HISTORIC PRESERVATION ADVISORY BOARD CASE MEMO

TO: Historic Preservation Advisory Board
DATE: November 18, 2021
APPLICANT: Haydon Frasier
CASE NUMBER: H2021-004; *Certificate of Appropriateness (COA) for 510 Williams Street*

The applicant is requesting approval of a Certificate of Appropriateness (COA) for the purpose of permitting a new residential fence and an extension of the existing exposed aggregate concrete driveway on the subject property.

- - - = 6' Iron Fence
 [Yellow Shaded Area] = New Driveway

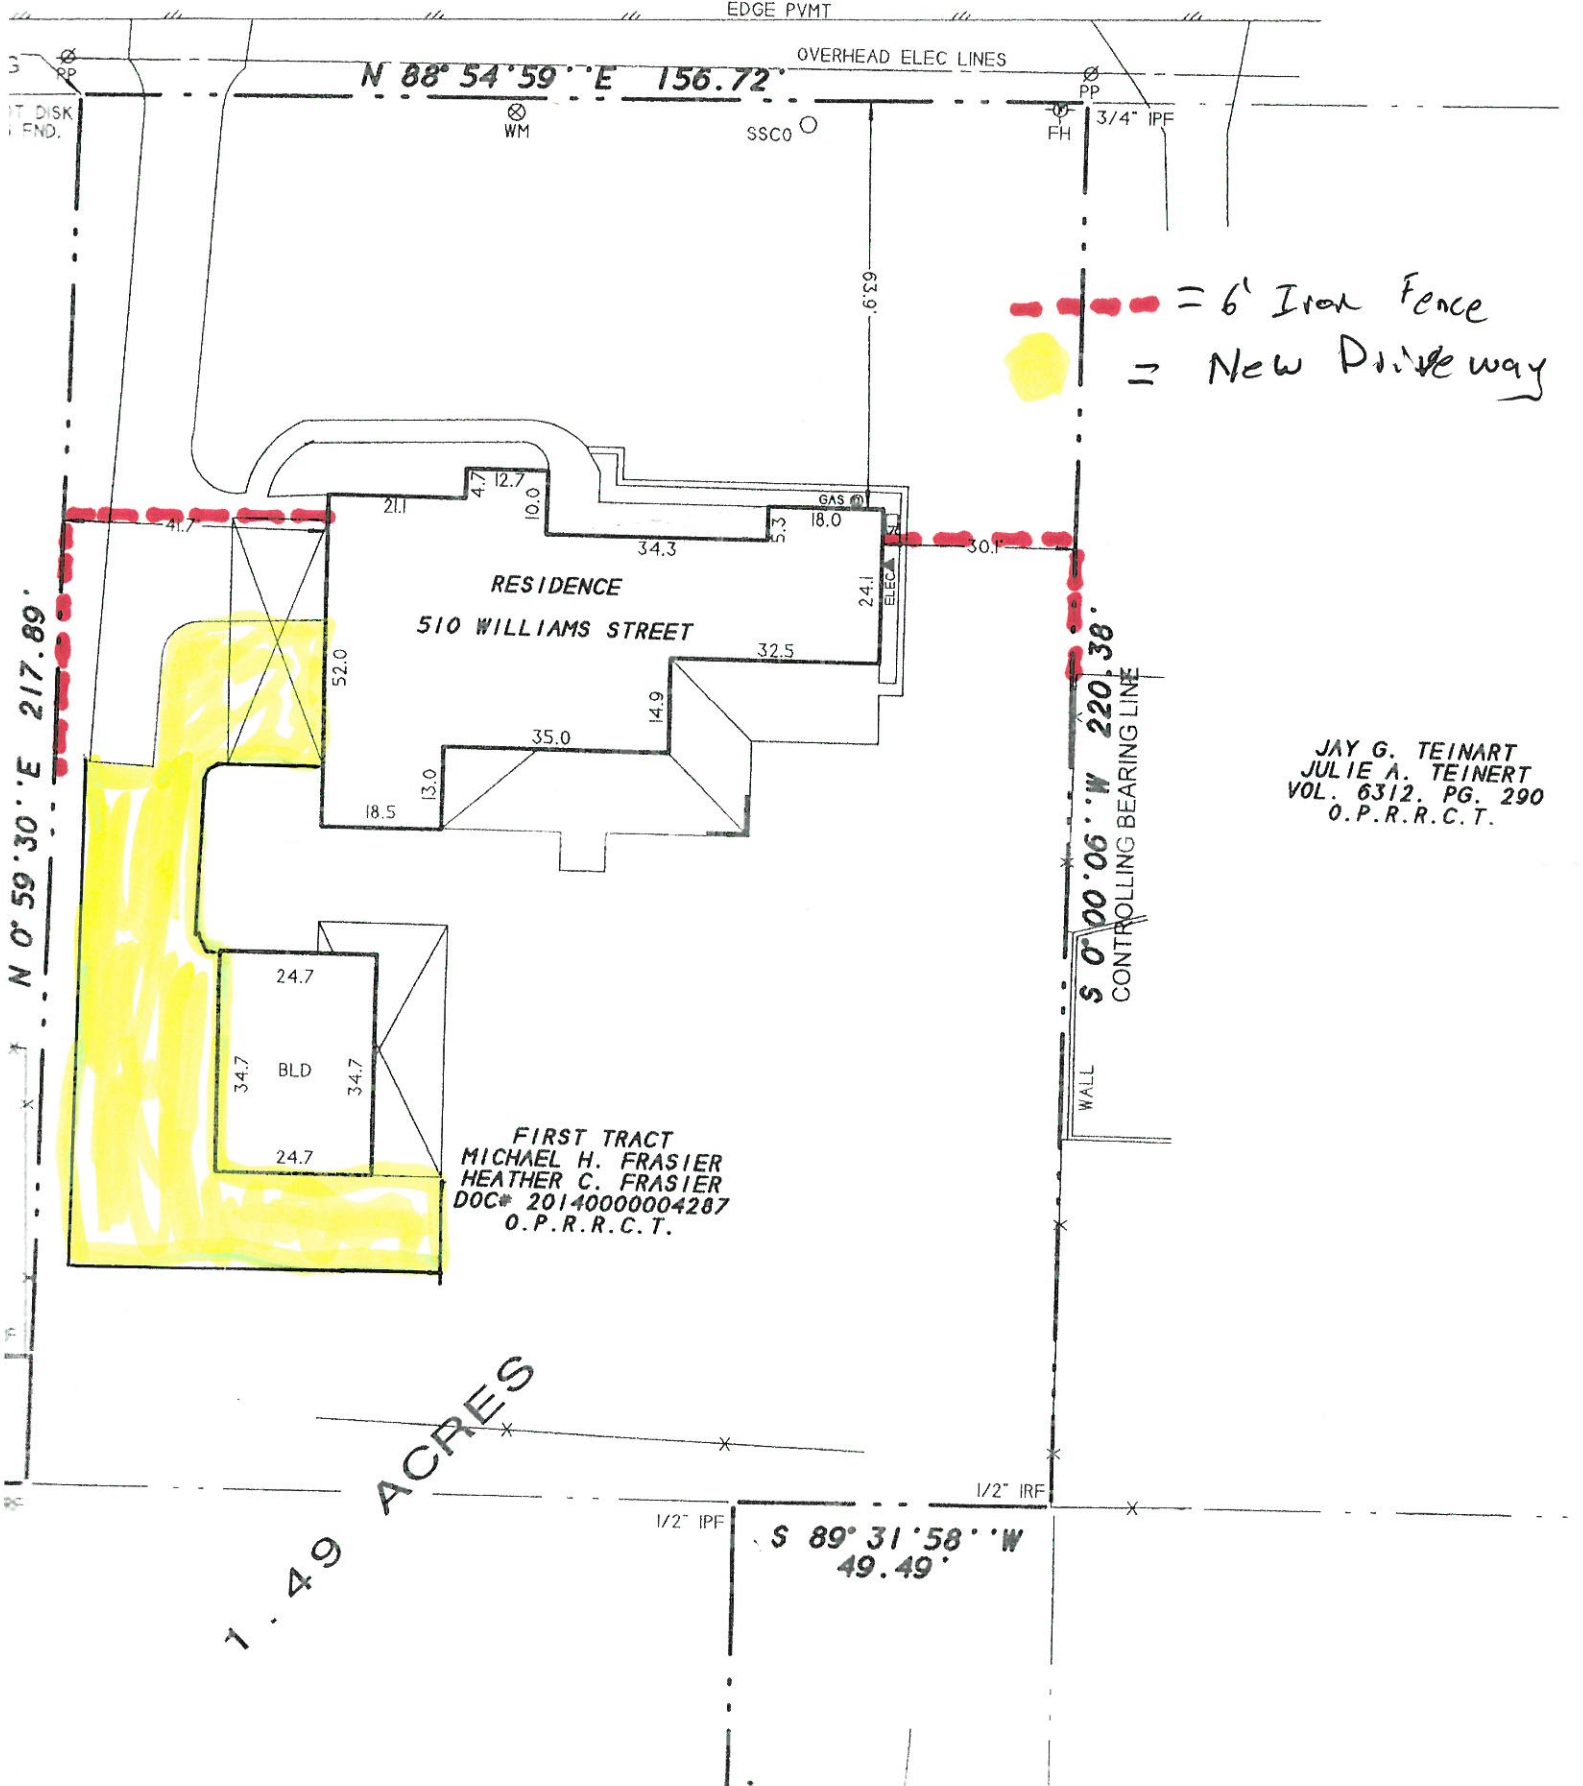
The applicant is proposing to place a six (6) foot high wrought iron fence along the northwest and northeast corners of the front façade of the home. The fence will partially continue along the east and west sides of the subject property. Additionally, the fence along the northeast front façade will incorporate an electrical gate at the driveway. The fence will be visible from Williams Street and the adjacent properties to the east and west. The applicant is also requesting to construction an extension of the existing driveway that will continue from the current location to the rear of the subject property and connect to the detached garage. The applicant is proposing that the extension incorporate the same exposed aggregate concrete appearance as the existing driveway.

According to Section 07(H), *Building Standards*, of Appendix D, *Historic Preservation Guidelines*, of the Unified Development Code (UDC), "(a) fence in the front, side, or rear yards should meet all applicable city codes ... Any fence that requires review must be architecturally compatible in height, materials, color, texture and design with the style and period of the main structure on the lot." In this case, the proposed wrought iron fence is visible from Williams Street. Currently, the adjacent properties to the east and west of the subject property have side and front wrought iron fences visible from Williams Street. The proposed wrought iron fence should not have a negative effect on the adjacent properties, and will match the existing character of the neighborhood.

According to Section 07(J)(1)&(2), *Building Standards*, of Appendix D, *Historic Preservation Guidelines*, of the Unified Development Code (UDC), "...(d)riveway and sidewalks should be paved with concrete, brick, cut stone, pavers, natural rock or asphalt. All new sidewalks and driveways should be constructed to be compatible in texture, color, style and size with the main structure on the lot." The applicant is proposing that the driveway extension utilize the same exposed aggregate concrete appearance as the existing driveway and extend to the existing garage on the subject property. In addition, Subsection 03.02, *Paving Materials*, of Article 06, *Parking and Loading*, of the Unified Development Code (UDC) states, "...(a)ll required parking and loading areas, public and private drives, and fire lanes shall be constructed of concrete, but may have a surface treatment of brick, stone or other similar material. However, cast interlocking concrete, brick, or stone pavers installed on a prepared base may be used in parking areas and on public and private drives where approved by the City Engineer." In this case, the City Engineer has approved the use of exposed aggregate concrete. Staff would also like to note that several properties throughout the Old Town Rockwall (OTR) Historic District utilize exposed aggregate concrete for driveways.

- (1) Any construction resulting from the approval of this request shall conform to the requirements set forth by the Unified Development Code (UDC), the International Building Code (IBC), the Rockwall Municipal Code of Ordinances, city adopted engineering and fire codes and with all other applicable regulatory requirements administered and/or enforced by the state and federal government.
